STRAWBERRY PARK RESIDENCE
STEAMBOAT SPRINGS
COLORADO

PLAN REVIEW COMMENTS

Job Address: tbd
Applicant: PF Wall, LLC.

Plan Log No. CB-06-438
Designer: CCA

SHEET NUMBER: A9.3

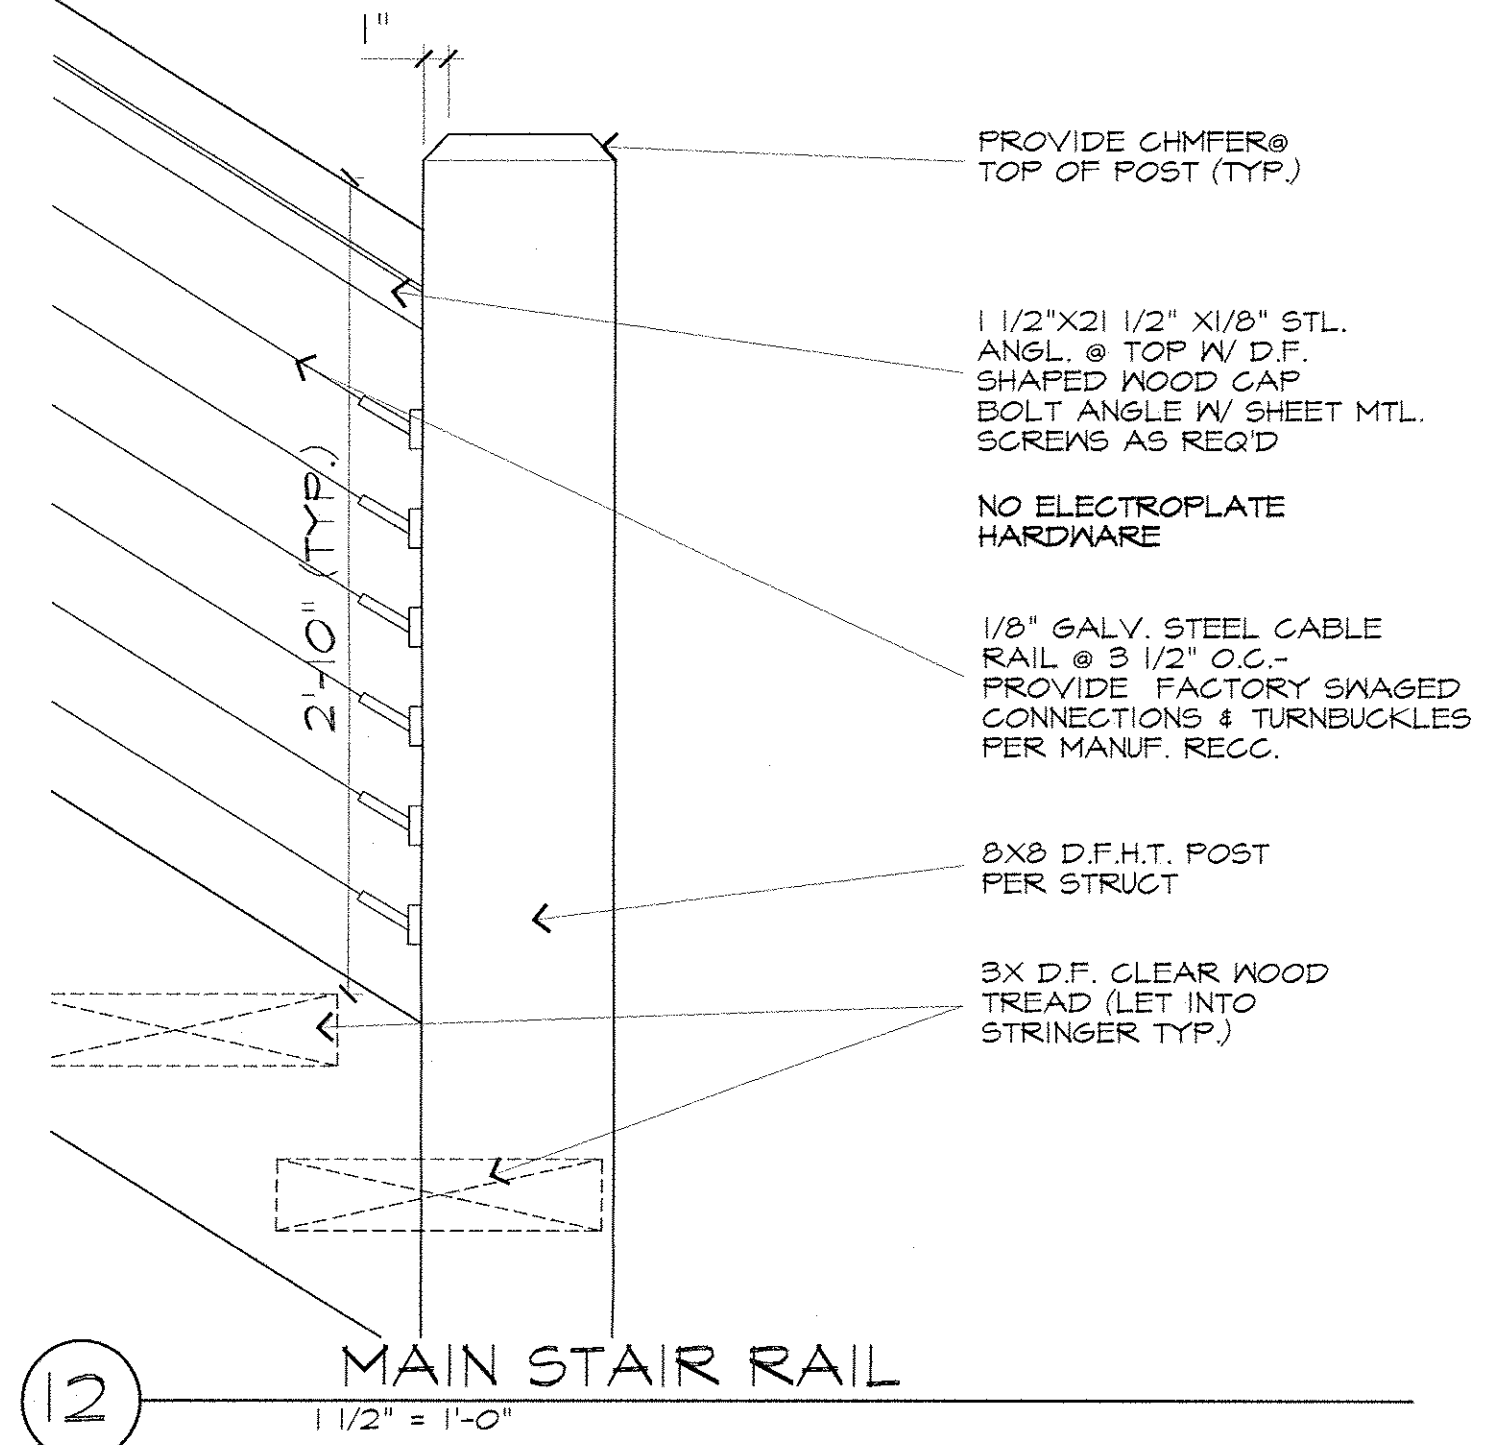
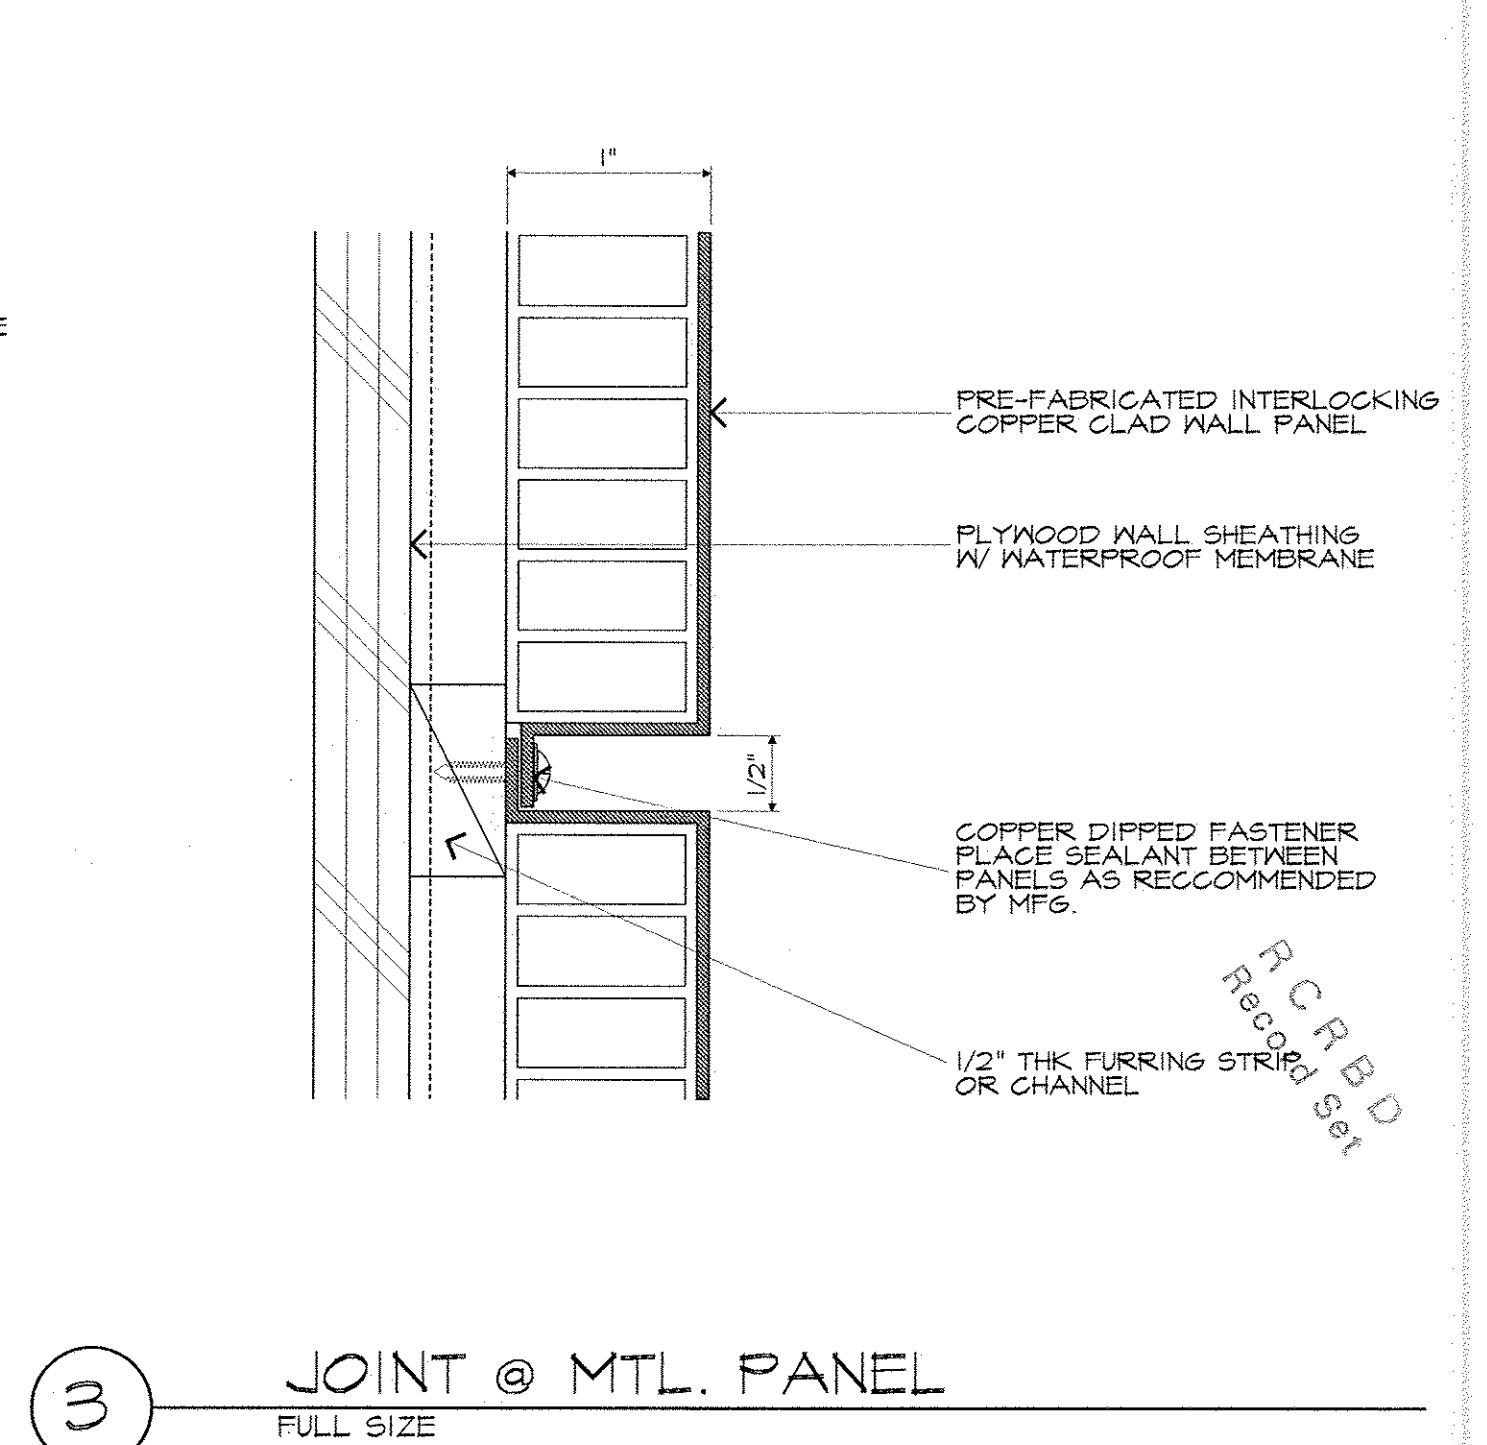
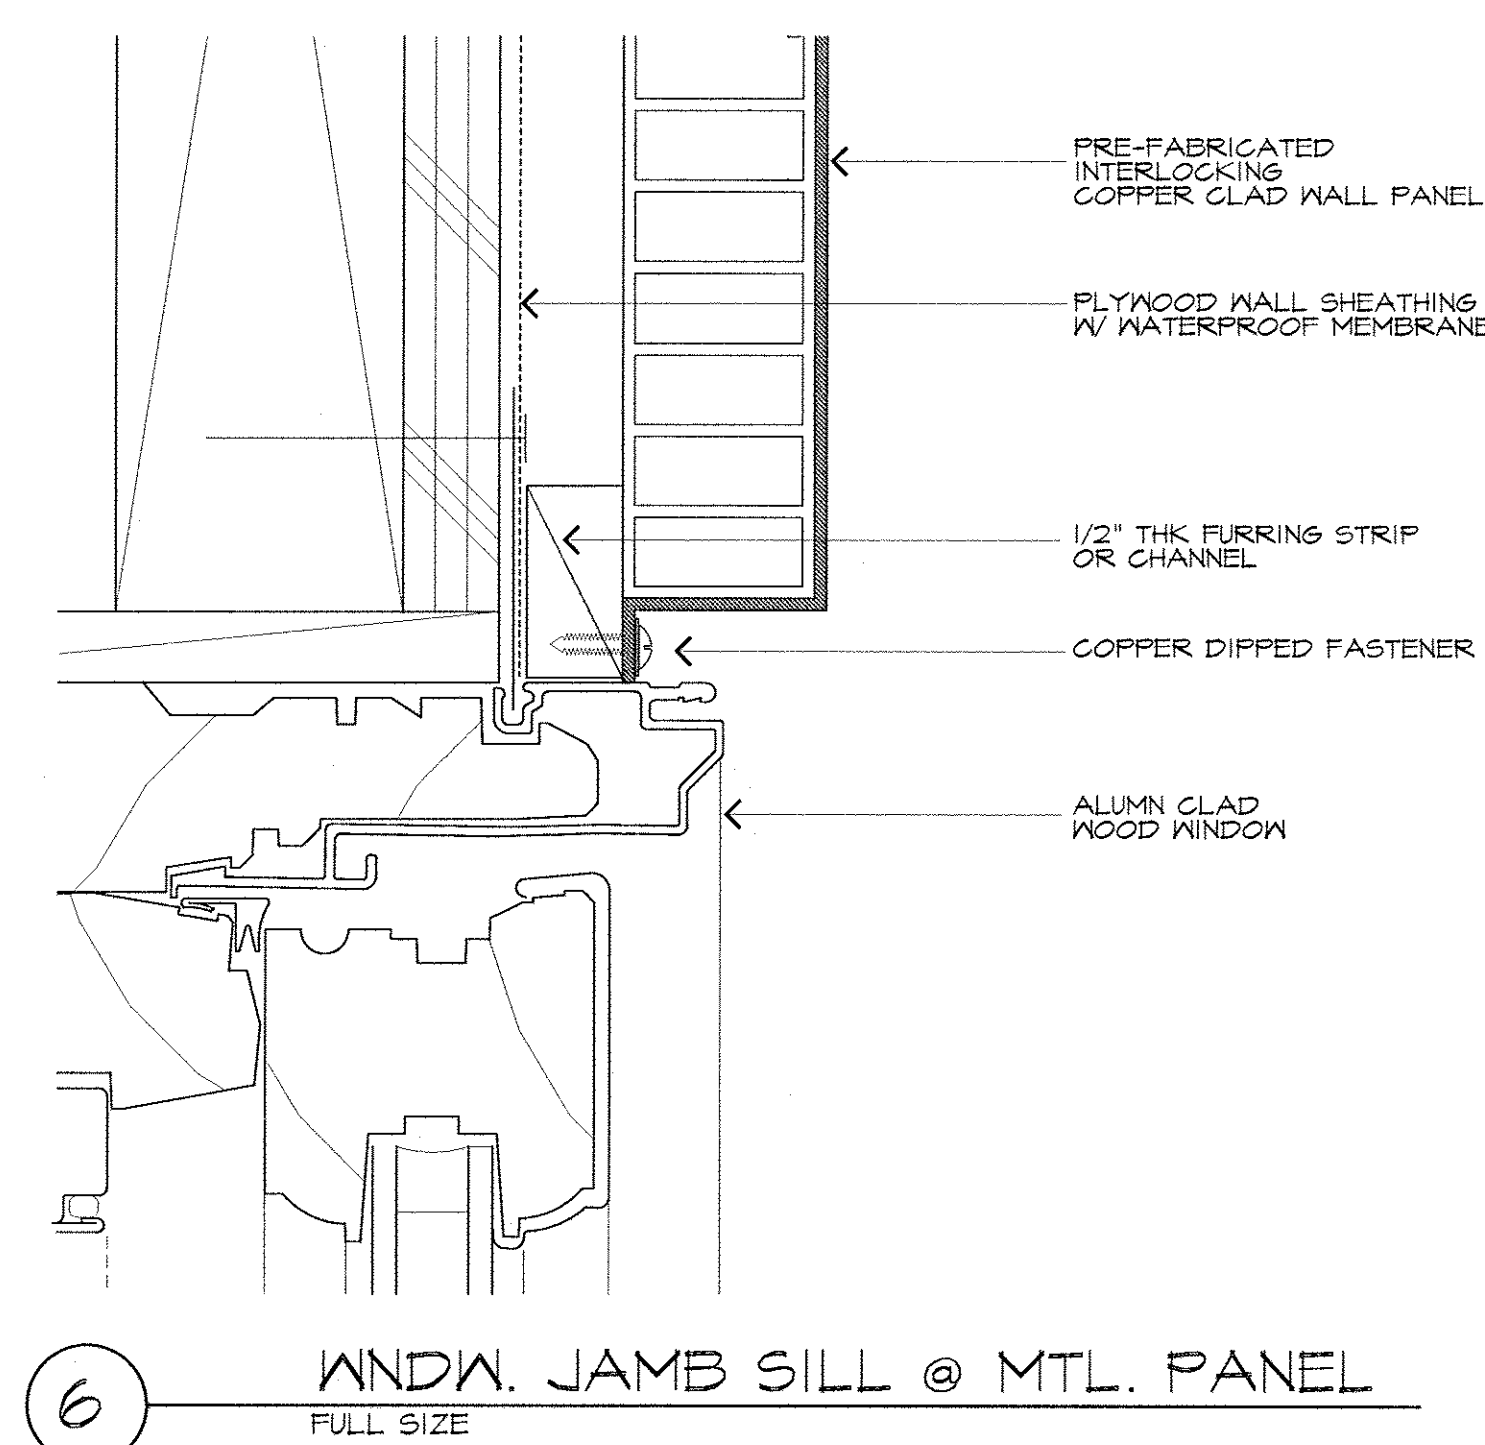
4. Provide a complete concrete fireplace design. See R1003. Show how you will comply with R1003.9, .10, .11, R1005.
5. Show how you will comply with "cablerail specifications". 5 & 12/A9.2 and 5 & 12/A9.3. Guardrails from aircraft cables Documentation from a manufacturer of cable guardrail explains that the cables must be installed at a spacing closer than that required by the UBC. The published installation instructions from this manufacturer show a maximum post spacing of 4.5 feet with a vertical spacer midway between the posts to hold the cables in line and prevent deflection of the wire. The maximum spacing of the cable is 3 inches o/c.

1. Foundation Only has been removed from the full set of structural drawings issued for full permit.
2. A retaining wall design for walls up to 10 feet has been provided.
3. A note has been added to the plans stating that the media room will receive light and ventilation per code minimums via artificial light and a HRV.
4. The fireplace specified is 5 piece modular conc. unit manufactured by Contempo Fireplaces, Alb, NM—A cut sheet, install manual and manufacturer details are contained in this document. (attached)
5. Manufacturer specs have been attached for the cable rails and details in plan set now reference this Manufacturer.
6. See item 4.
7. Complete structural drawings have been provided.
